Work Order ID: 114896

Item Name: Crosstube Turning Detail

DART AEROSPACE LTD		Work Order:	114896
Description: Crosstube Assembly		Part Number:	D407-667-145
Inspection Dwg: D407-667-145 Rev: C		Page 1 of 2

DRAWING NO. D407-667-145	TITLE CROSSTUBE ASS'Y (407 HIGH FWD)	REV. C	DART AEROSPACE LTD ENGINEERING ORDER		D.E.O. NO. D407-667-145-C-1	SHEET NO. SHEET 1 OF 1	SCALE NTS
DRAWN <i>Q</i>	CHECKED <i>ASS</i>	MFG. APPR. <i>AB</i>	APPROVED <i>WD</i>		DE APPR. <i>AB</i>		
DATE 11.07.15	DATE 11.07.22	DATE 11.07.22	DATE 11/07/22		DATE 11.07.21

TURNING DETAIL

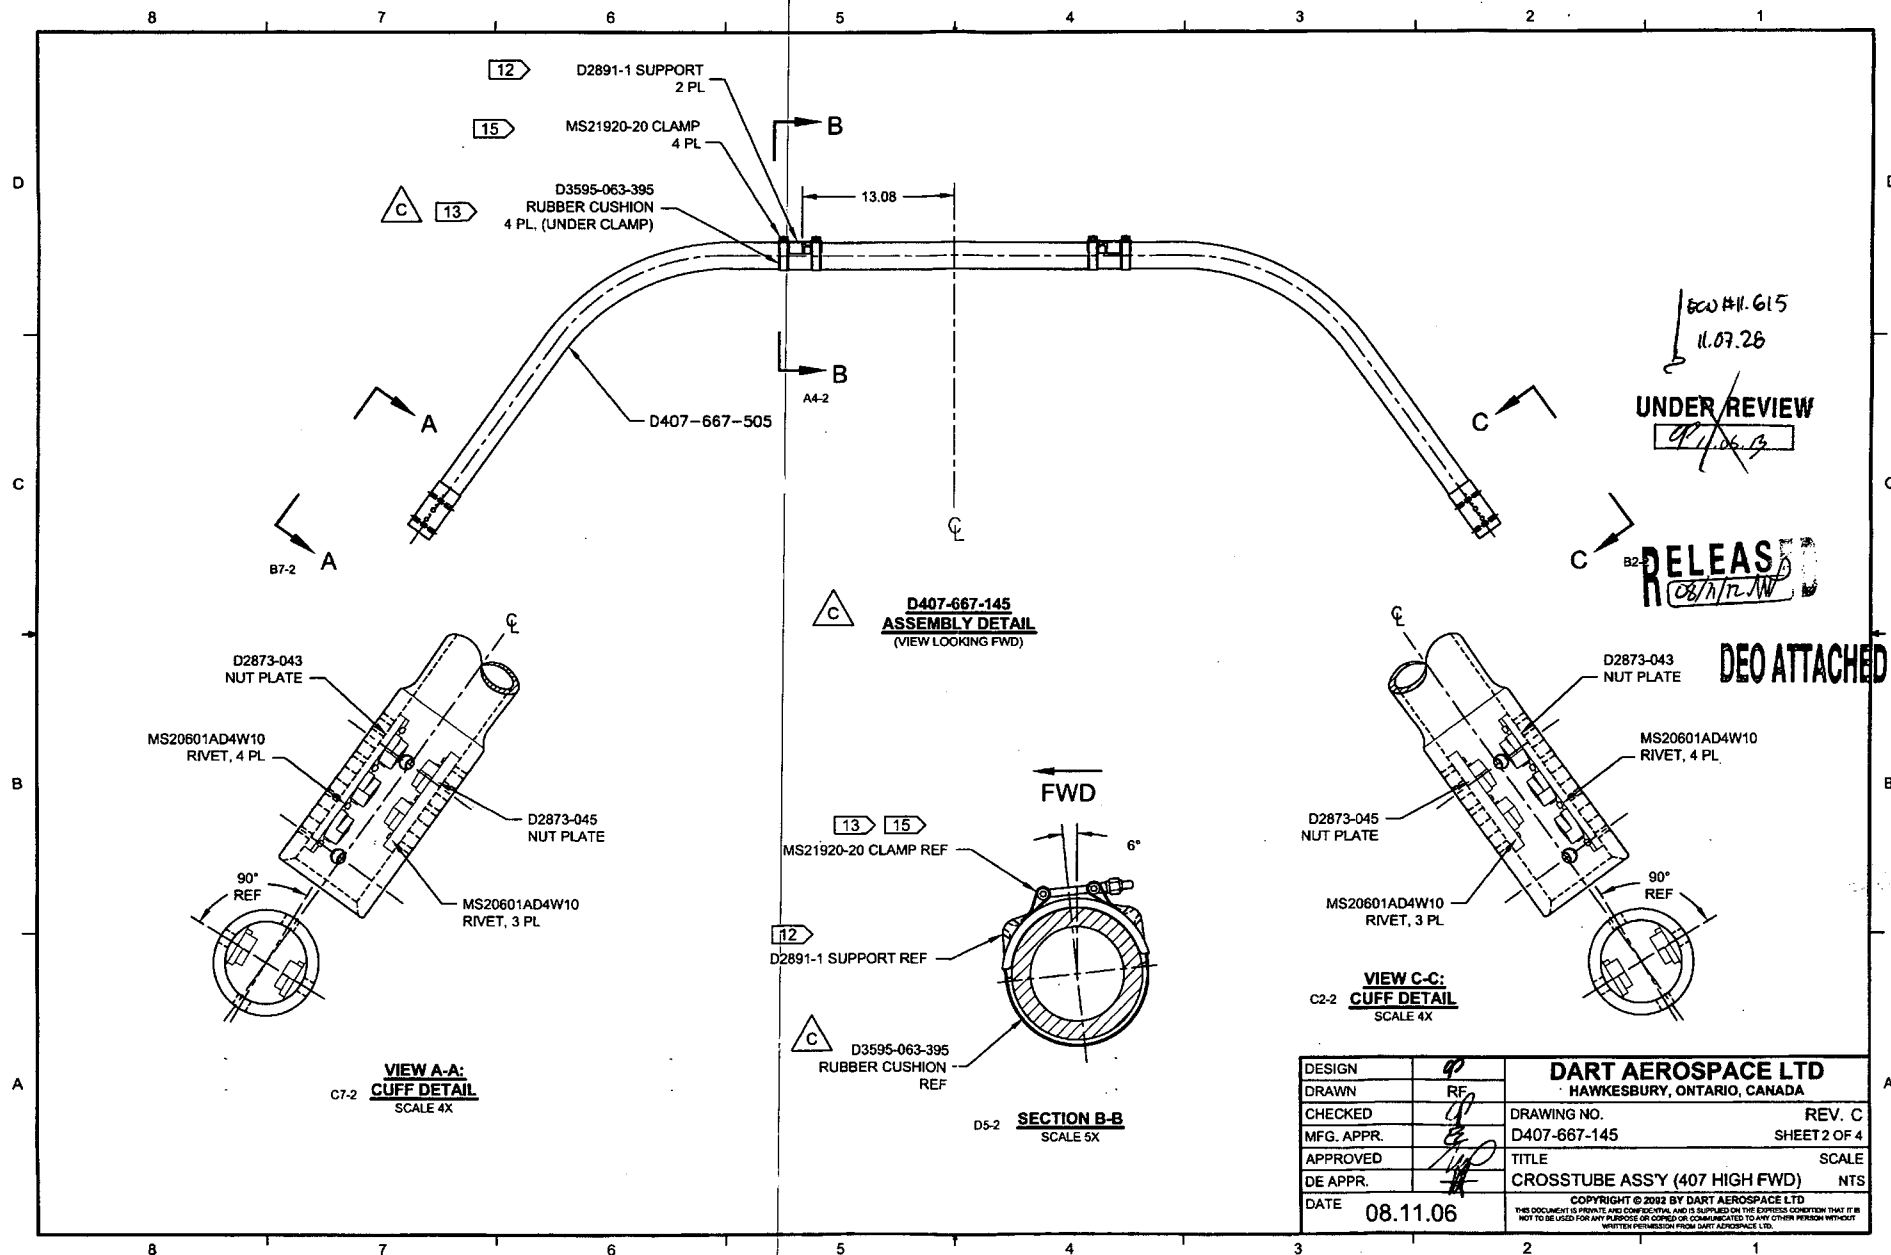
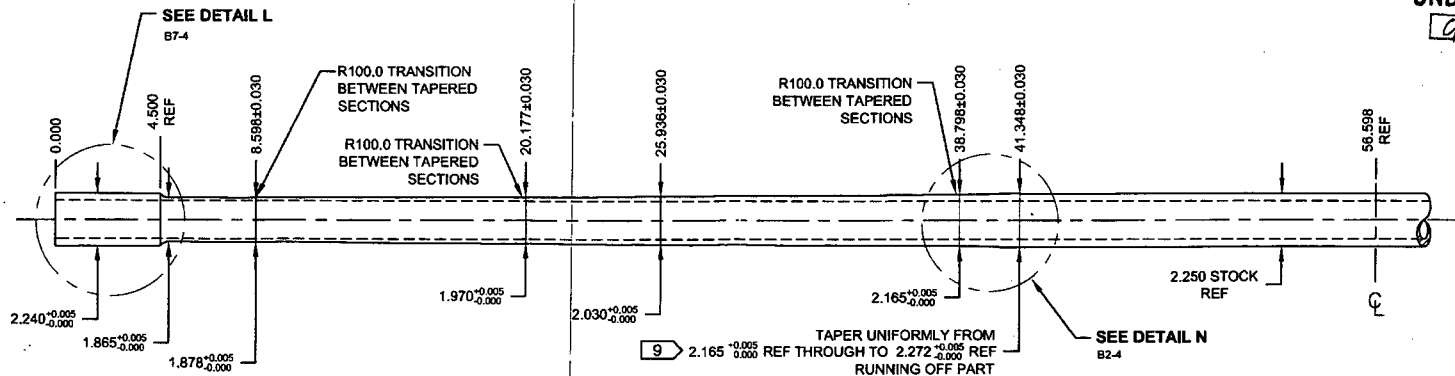
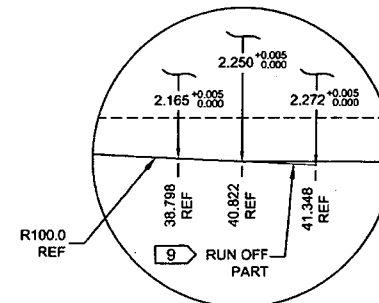
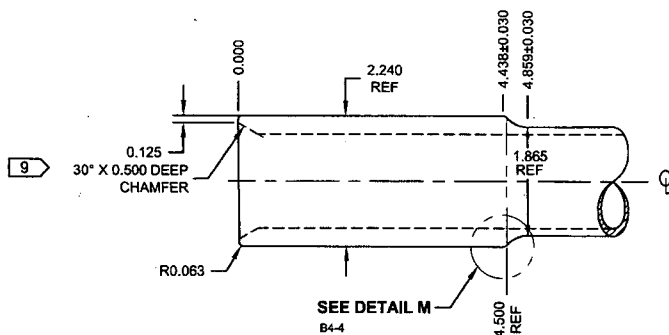
C	REVISE GENERAL NOTES/PART LIST (ZN D7-1); REORGANIZED VIEWS AND REFORMATTED DRAWING TO CURRENT STANDARDS. D3595-063-395 WAS D2856-400-694 (ZN D6-2 & A5-2); REMOVED REF. 7 ADD TOLERANCES (ZN C6-3, C4-3, D2-3); RELOCATED FLAG #6 (ZN A8-3) PER NCR 210; MOVED TURNING DETAIL & UPDATED TOLERANCE TO SHEET 4.	RF	08.11.06
B	ADD HOLES AND NUT PLATES FOR COMPATABILITY WITH BHT/AA SKUDTUBES	PH	05.07.26
A	NEW ISSUE	CP	02.05.08
REV.	DESCRIPTION	BY	DATE
DESIGN	RF	DART AEROSPACE LTD HAWKESBURY, ONTARIO, CANADA	
DRAWN	RF	DRAWING NO.	REV. C
CHECKED	RF	D407-667-145	SHEET 1 OF 4
MFG. APPR.	RF	TITLE	SCALE
APPROVED	RF	CROSSTUBE ASS'Y (407 HIGH FWD)	NTS
DE APPR.	RF	COPYRIGHT © 2002 BY DART AEROSPACE LTD THIS DOCUMENT IS PRIVATE AND CONFIDENTIAL AND IS SUPPLIED ON THE EXPRESS CONDITION THAT IT IS NOT TO BE USED FOR ANY PURPOSE OR COPIED OR COMMUNICATED TO ANY OTHER PERSON WITHOUT WRITTEN PERMISSION FROM DART AEROSPACE LTD.

DETAIL P
BONDING STRAP INSTALLATION 2 PL

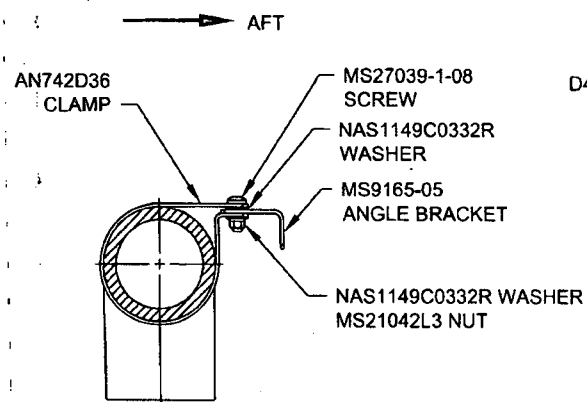
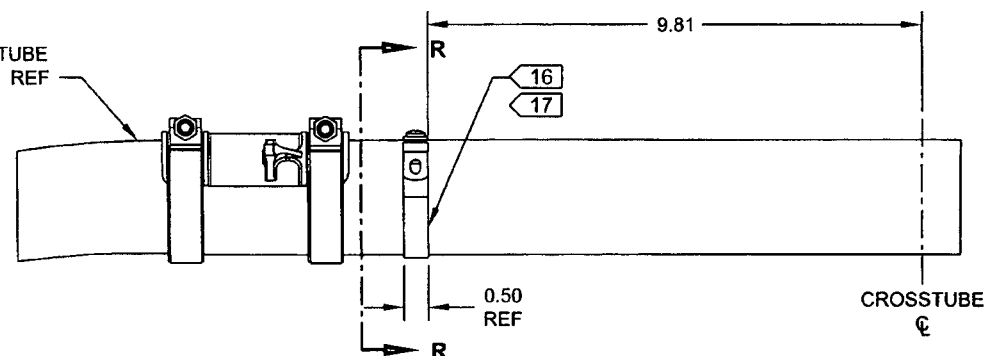
ADD ELECTRICAL GROUNDING STRAP

ITEM	QTY -145	PART NUMBER	DESCRIPTION
1	X	D407-667-145	CROSSTUBE ASSEMBLY (407 HIGH FWD)
10	2	AN742D36	CLAMP
11	2	MS9165-05	ANGLE BRACKET
12	2	MS21042L3	NUT (OR MS21042-3)
13	2	MS27039-1-08	SCREW
14	4	NAS1149C0332R	WASHER (OR AN960C10L)

- 16) MASK AREA UNDER CLAMP PRIOR TO PAINTING
- 17) SEAL EDGES WHERE AN742D36 CLAMP MEETS WITH THE CROSSTUBE USING SIKAFLEX-241/291 OR MIL-S-8802 CLASS B2 OR PROSEAL 890 SEALANT
- 18) PERFORM RESISTANCE CHECK TO ENSURE MAX RESISTANCE IS 10 MILLIOHMS
